CITY OF ALLENTOWN

R119 – 2025

HDC-2025-00064

Address: 428-436 N. 6th Street

Proposed Building Rendering (Applicant)

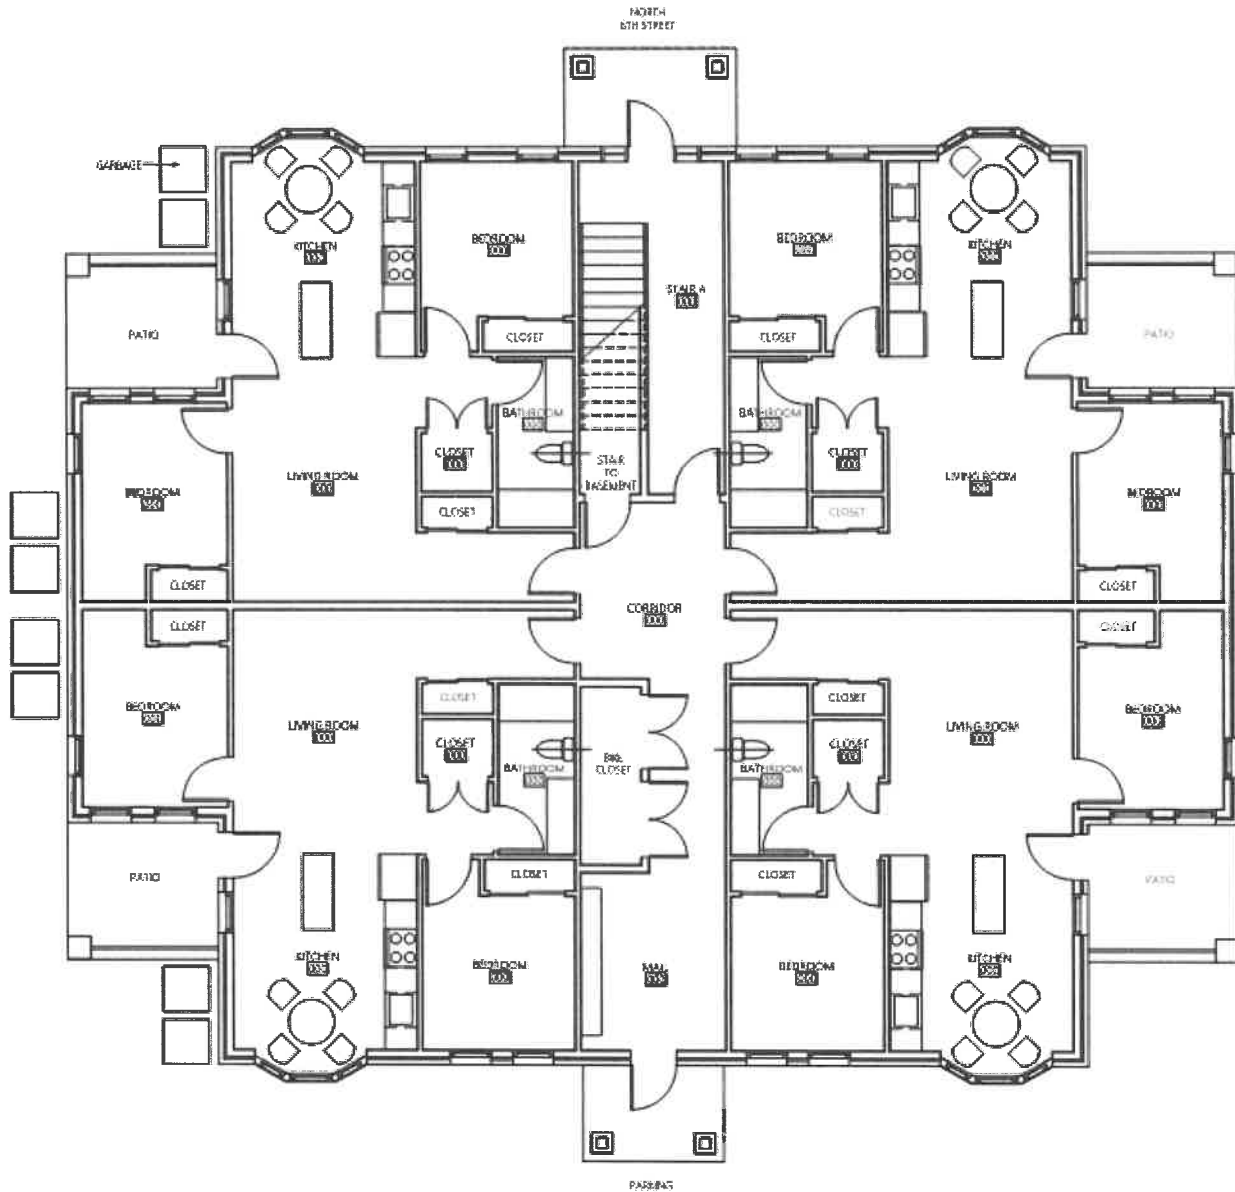
The submitted rendering indicates that the existing (perhaps original) stone wall at the 6th Street sidewalk will remain, which would be appropriate.

The materiality of the exterior is in keeping with the Guidelines, and the façade composition follows cues from other historic structures.

Mr. Huber noted that the Hardi siding should be smooth rather than textured siding. Mr. Jordan asked about the orientation of the siding – vertical or horizontal. Ms. Falcone noted that this is still an open design item, but the current preference is to orient the siding horizontally. Mr. Hammond stated he had no preference, but it should be one consistent direction wherever the siding is installed.

Ms. Falcone noted that an asphalt shingle roofing would be installed. Mr. Hart asked the Board if a shake would be acceptable. The Board agreed that any roofing besides a shake would be appropriate.

The Board discussed the windows, and that the double-hung, vertical orientation should be consistent at all windows.

1. All windows will be vertically oriented on the façade (height greater than width)
2. Hardi Board will have a smooth finish on visible facades
3. No shake shingles for the roof
